Item Name: Crosstube Turning Detail

DART AEROSPACE LTD	Work Order:	97871
Description: Crosstube Assembly	Part Number:	D407-667-145
Inspection Dwg: D407-667-145 Rev: C		Page 1 of 2

DRAWING NO. D407-667-145	TITLE CROSSTUBE ASS'Y (407 HIGH FWD)	REV. C	DART AEROSPACE LTD ENGINEERING ORDER		D.E.O. NO. D407-667-145-C-1	SHEET NO. SHEET 1 OF 1	SCALE NTS
DRAWN 9	CHECKED ASS	MFG. APPR. iB	APPROVED WD		DE APPR. H		
DATE 11.07.15	DATE 11.07.22	DATE 11.07.22	DATE 11/07/22		DATE 11.07.21

DRAWING NO. D407-667-145	TITLE CROSSTUBE ASS'Y (407 HIGH FWD)	REV. C	DART AEROSPACE LTD ENGINEERING ORDER		D.E.O. NO. D407-667-145-C-2	SHEET NO. SHEET 1 OF 1	SCALE NTS
DRAWN AJS	CHECKED	MFG. APPR.	APPROVED		DE APPR.		
DATE 12.08.02	DATE 12.08.02	DATE 12.08.02	DATE 12.08.02		DATE 12.08.02

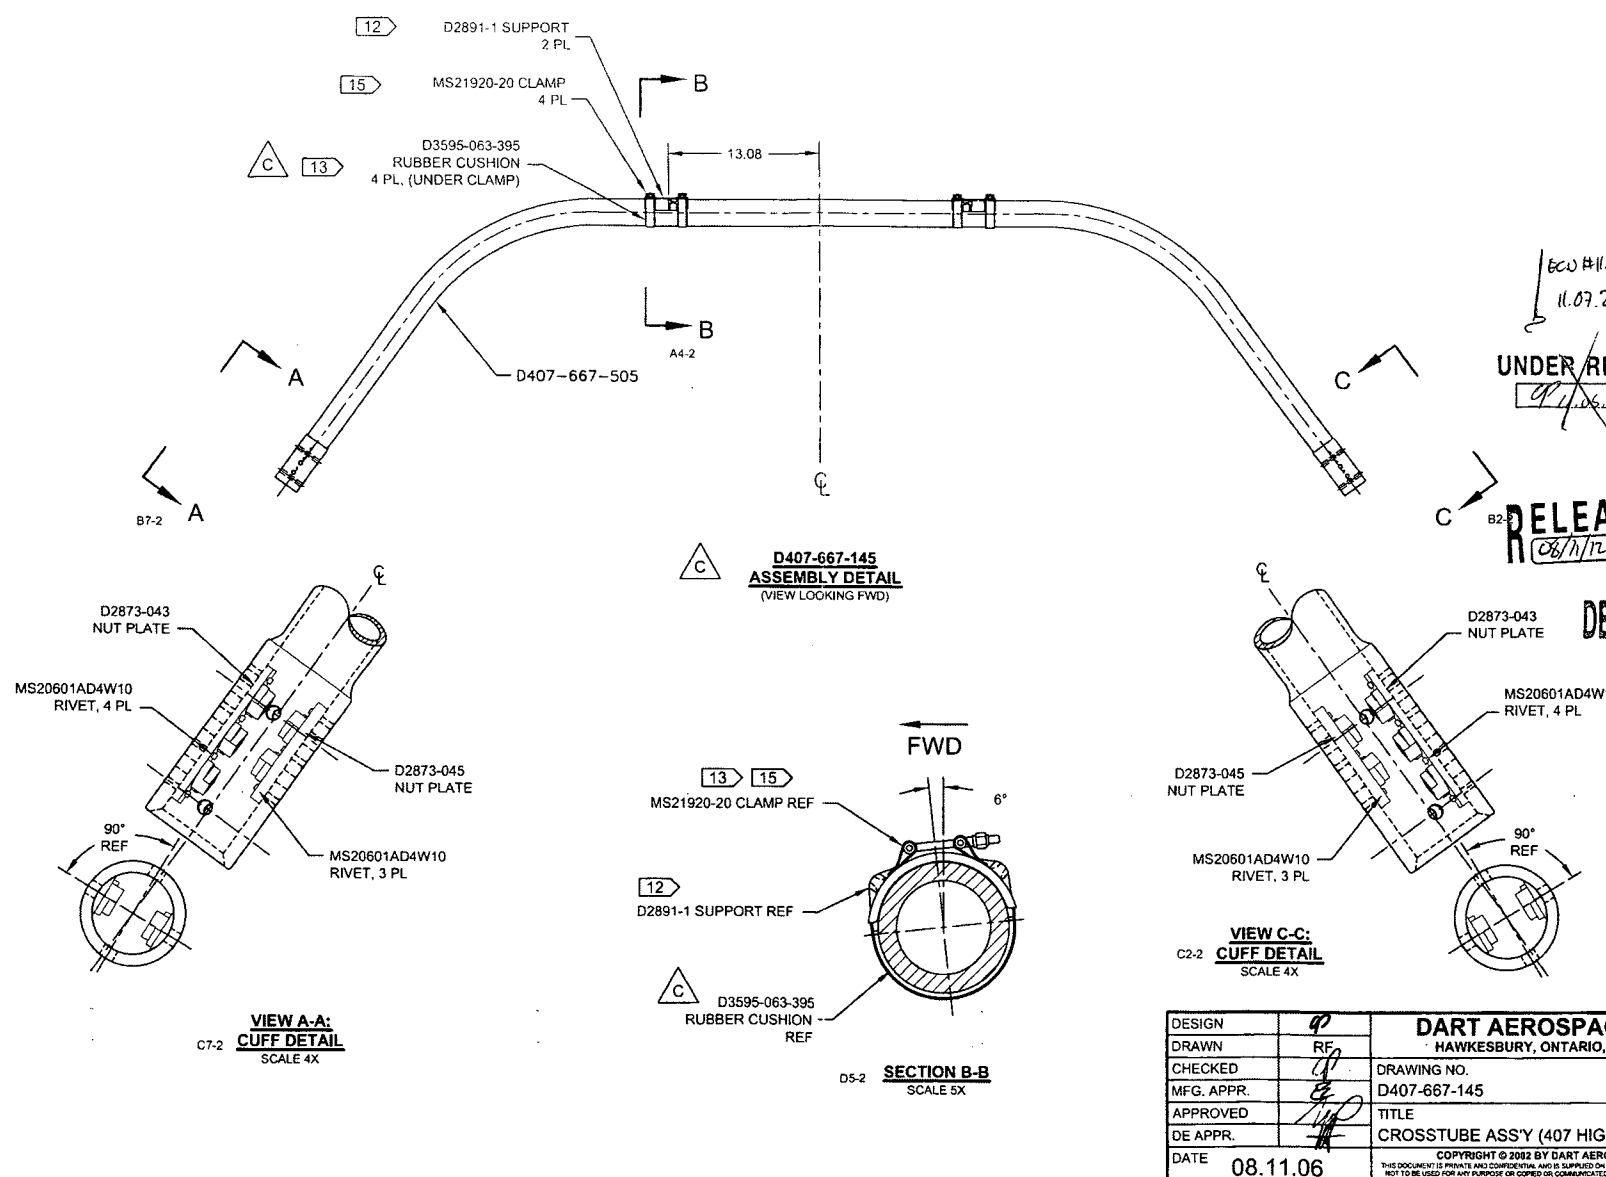
C	REVISE GENERAL NOTES/PART LIST (ZN D7-1); REORGANIZED VIEWS AND REFORMATTED DRAWING TO CURRENT STANDARDS. D3595-063-395 WAS D2856-400-694 (ZN D6-2 & A5-2); REMOVED REF. 7 ADD TOLERANCES (ZN C6-3, C4-3, D2-3); RELOCATED FLAG #6 (ZN A8-3) PER NCR 210; MOVED TURNING DETAIL & UPDATED TOLERANCE TO SHEET 4.	RF	08.11.06
B	ADD HOLES AND NUT PLATES FOR COMPATABILITY WITH BHT/AA SKUDTUBES	PH	05.07.26
A	NEW ISSUE	CP	02.05.08
REV.	DESCRIPTION	BY	DATE
DESIGN	RF	DART AEROSPACE LTD HAWKESBURY, ONTARIO, CANADA	
DRAWN	RF	DRAWING NO. REV. C D407-667-145 SHEET 1 OF 4	
CHECKED	RF	TITLE SCALE CROSSTUBE ASSY (407 HIGH FWD) NTS	
MFG. APPR.	RF	DATE 08.11.06	
APPROVED	RF	COPYRIGHT © 2002 BY DART AEROSPACE LTD THIS DOCUMENT IS PRIVATE AND CONFIDENTIAL AND IS SUPPLIED ON THE EXPRESS CONDITION THAT IT IS NOT TO BE USED FOR ANY PURPOSE OR COPIED OR COMMUNICATED TO ANY OTHER PERSON WITHOUT WRITTEN PERMISSION FROM DART AEROSPACE LTD.

TURNING DETAIL

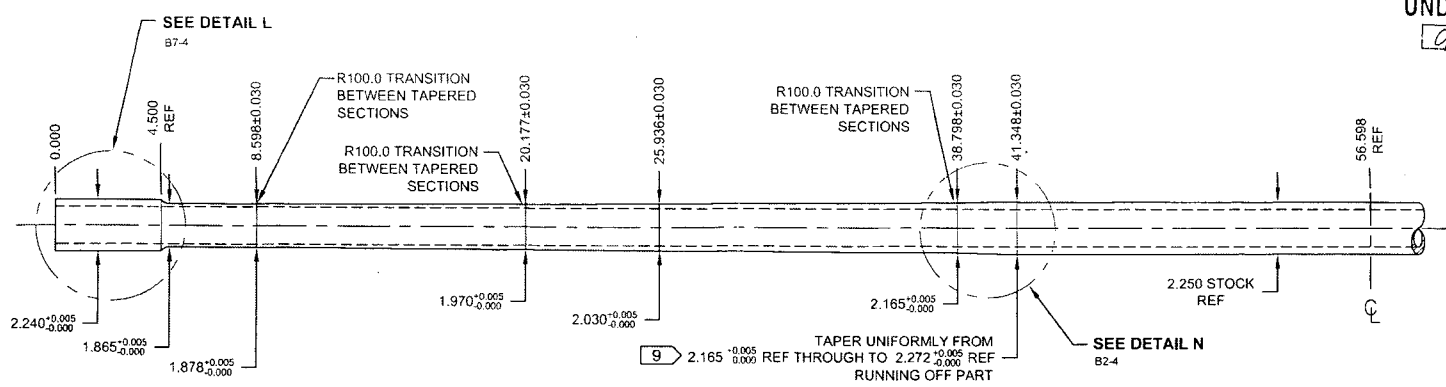
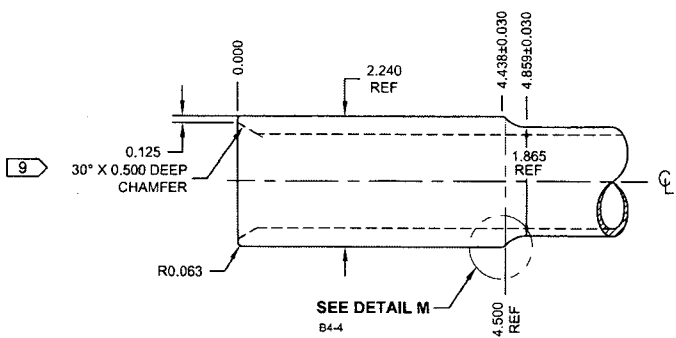
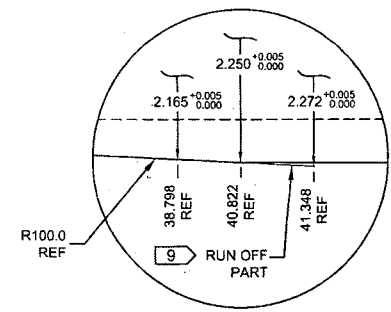
1-Fill tube with sand & install plugs DT8673 on both ends as per Folio FA249

2-Turn first side as per Folio FA249

3-Blend transition lines only, **do not sand whole tube**:

1-Turn second side as per Folio FA249

2-Blend transition lines only, **do not sand whole tube**:

GRIND ONLY TRANSITION LINES SMOOTH LONGITUDE WAY.
